DEPARTMENT REPORT

HEARING 1/27/2026
 DATE:
 TO: Mayor & City Council
 FROM: Sonya Allen, Associate Planner
 208-884-5533
 sallen@meridiancity.org
 APPLICANT: Patrick Connor, Ardurra
 SUBJECT: SHP-2025-0005
 Mogul North
 LOCATION: 4305 W. Grand Mogul Dr., in the southeast 1/4 of Section 15, T.3N., R.1W. (Parcel #R8956280200)

B. Short Plat (date: 9/24/2025)

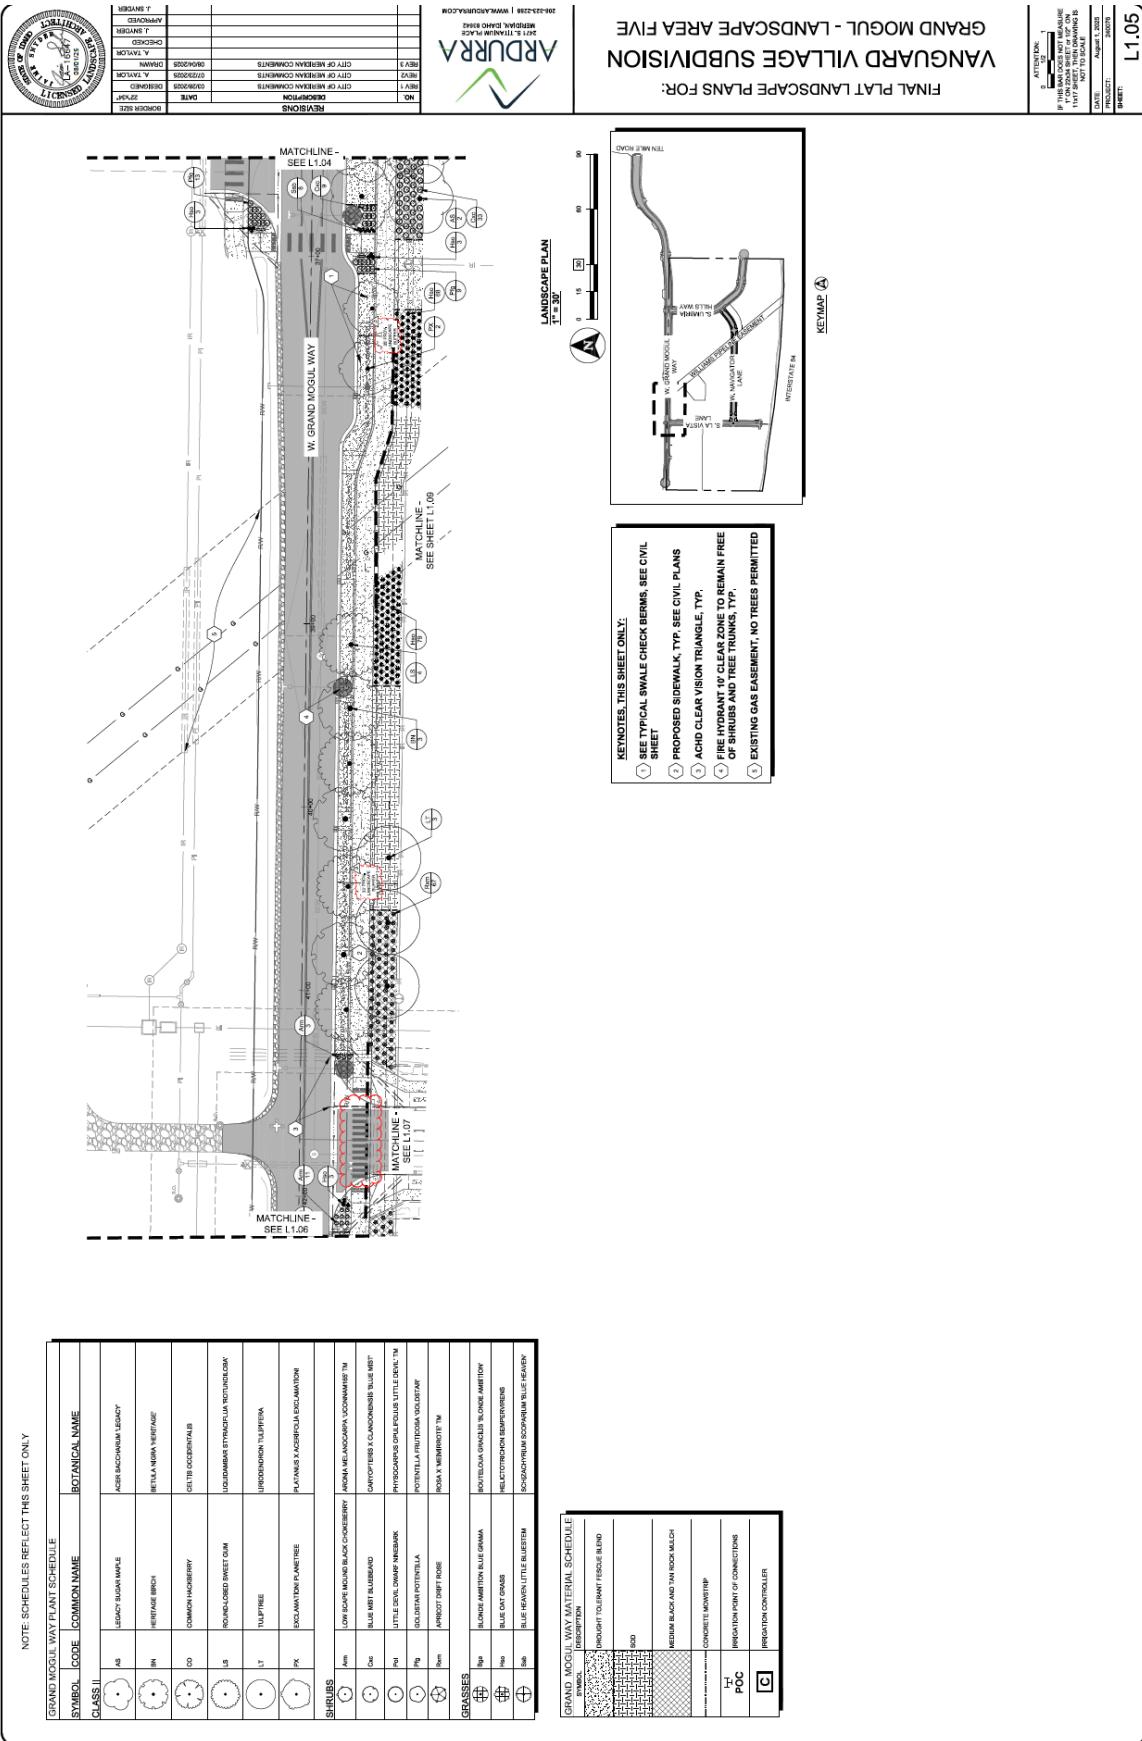
2. Future development shall be consistent with the minimum dimensional standards listed in UDC Table 11-2B-3 for the M-E and H-E zoning districts.
3. The short plat shall include the following revisions:

- a. Include a note granting cross-access easements between all the proposed lots for internal cross-access and access via W. Grand Mogul Dr. and S. La Vista Ln.; or record a separate easement granting such and reference the recorded instrument number in a note on the plat. If parking will be shared between the proposed lots, a cross-parking agreement/easement should also be recorded and/or noted on the plat.

- b. Include a note granting a blanket cross-access easement to the property to the west (Parcel #S1215325450) per UDC 11-3A-3A.2; or record a separate easement granting such and reference the recorded instrument number in a note on the plat.

- c. Note #14: Include the recorded instrument number of the cross-access easement.
4. Street buffer landscaping shall be installed by the developer of Vanguard Village Subdivision No. 1 per the landscape plan approved with that subdivision (FPS-2025-0014), included below in Section VII.C.

C. Landscape Plan Approved with Vanguard Village Subdivision No. 1 (date: 8/1/2025)

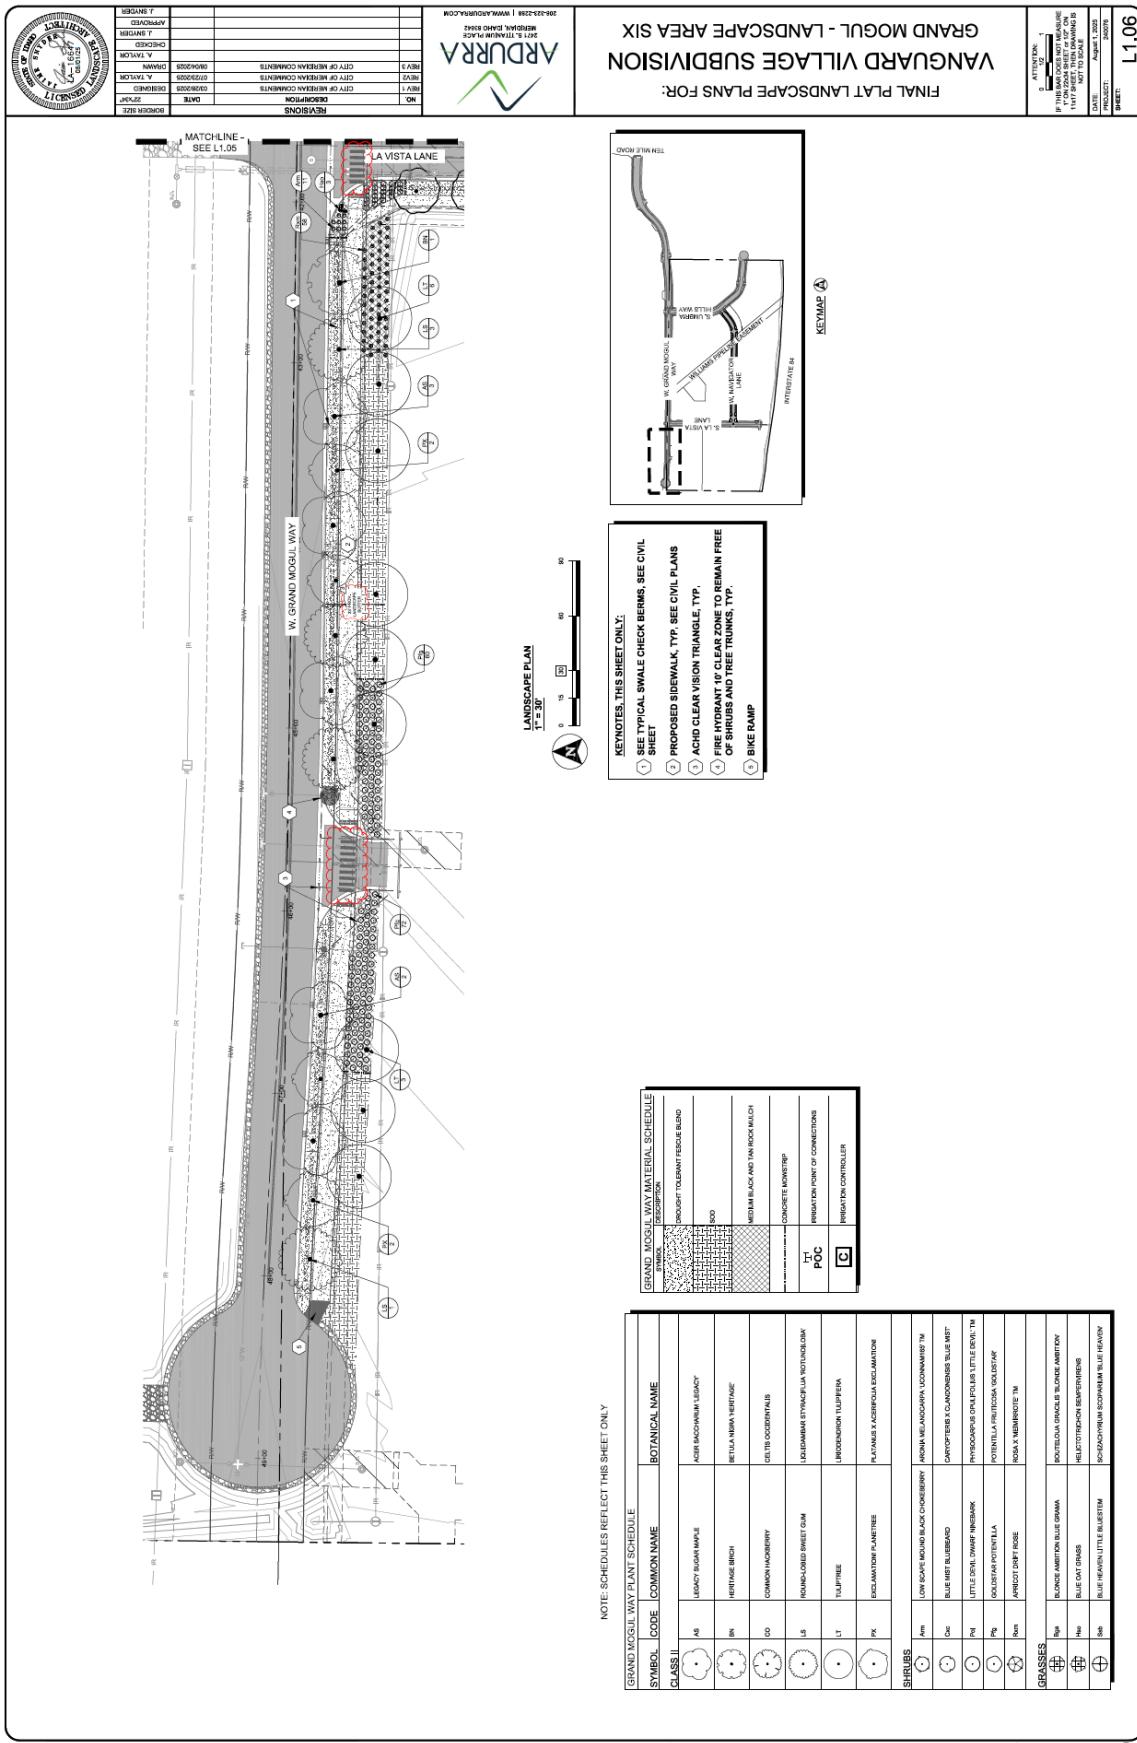
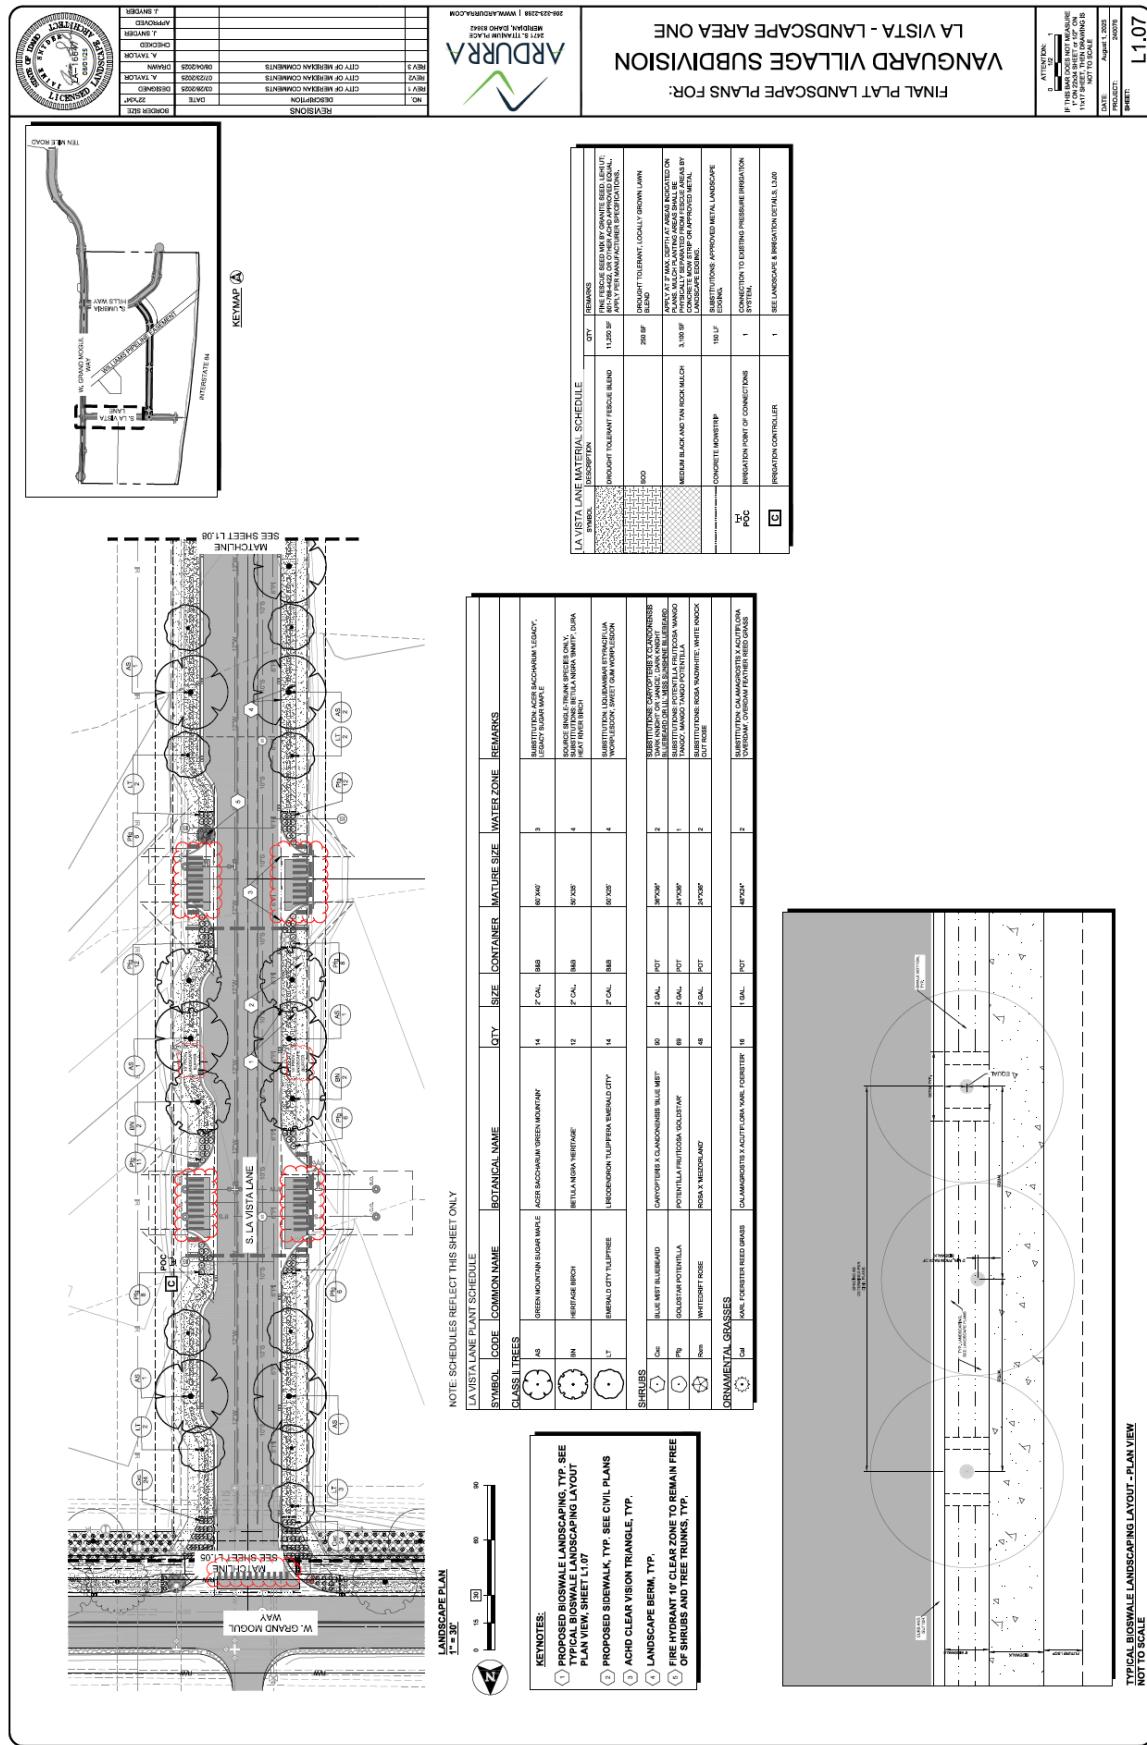
Wastewater	
• Distance to Sewer Services	
• Sewer Shed	
• Estimated Project Sewer ERU's	See application
• WRRF Declining Balance	
• Project Consistent with WW Master Plan/Facility Plan	Yes
• Impacts/concerns	<ul style="list-style-type: none"> • See Public Works Site Specific Conditions
Water	
• Distance to Water Services	Water Available at Site
• Pressure Zone	
• Estimated Project Water ERU's	See application
• Water Quality	None
• Project Consistent with Water Master Plan	Yes
• Impacts/Concerns	None - Ensure no trees are located within 10' of the Water Meter per the Landscaping plan it needs to be adjusted accordingly

1. Provide 20' Easements for mains, hydrant laterals and water services. Easements should extend up to the end of main/hydrant/water meter and 10' beyond it.
2. No permanent structures (trees, bushes, buildings, carports, trash receptacle walls, fences, infiltration trenches, light poles, etc.) to be built within the utility easement.
